<b>DOCKETED</b>	
<b>Docket Number:</b>	21-AFC-02
<b>Project Title:</b>	Willow Rock Energy Storage Center
<b>TN #:</b>	263490
<b>Document Title:</b>	Kern County Planning and Natural Resources Department Comments - Additional Comment - Recommended Conditions
<b>Description:</b>	N/A
<b>Filer:</b>	System
<b>Organization:</b>	Kern County Planning and Natural Resources Department
<b>Submitter Role:</b>	Public Agency
<b>Submission Date:</b>	5/29/2025 1:45:08 PM
<b>Docketed Date:</b>	5/29/2025

**Additional Comment - Recommended Conditions**

**RE: Hydrostor Willow Rock Energy Storage Center – Kern County Comments and Requested  
Conditions of Approval (21-AFC-02) – Location – APN 431-022-13**

# **PARCEL MAP No 260** BEING A DIVISION OF A PORTION OF THE S. 1/2 OF THE S. 1/4 OF SECTION 33, T.10N, R.12W, S.B. 11. IN THE UNINCORPORATED TERRITORY OF THE COUNTY OF KERN, STATE OF CALIFORNIA

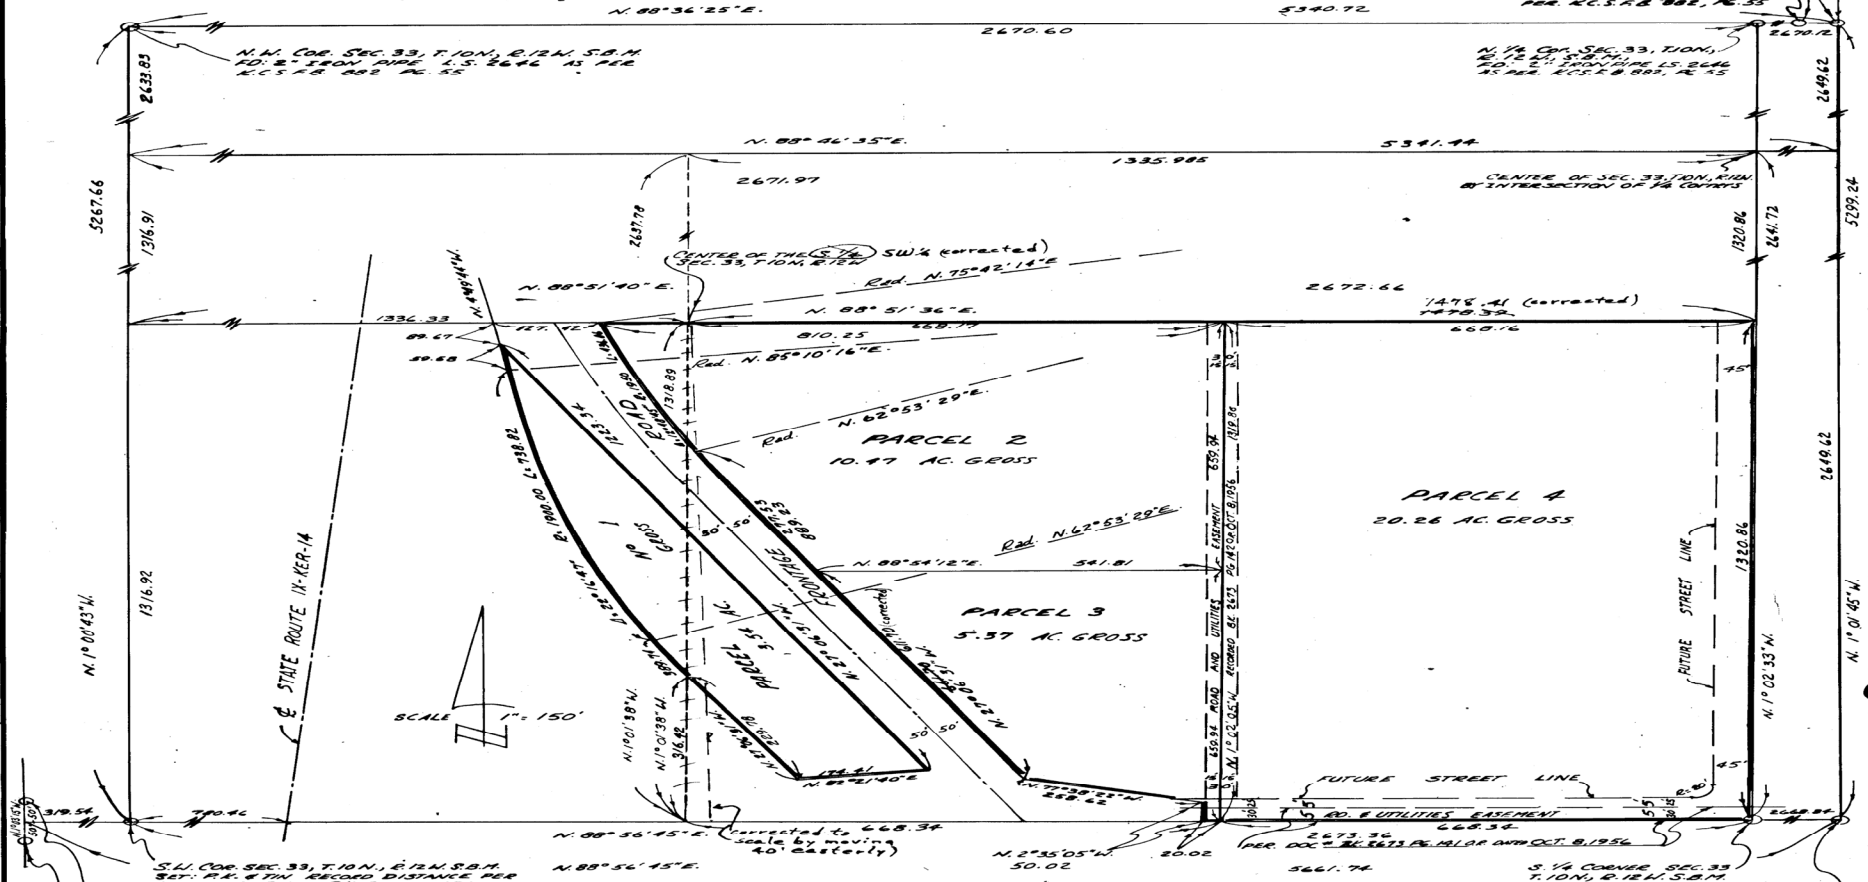
1. Prior to the commencement of construction, the applicant shall provide an irrevocable offer of dedication to the County of Kern for:
  - a. Dawn Road - 55 feet from the centerline of the road for all subject property and the off-site portion of Dawn Road from the westerly project boundary line to the westerly boundary line of Lot 3 of Parcel Map No. 260 (attached).
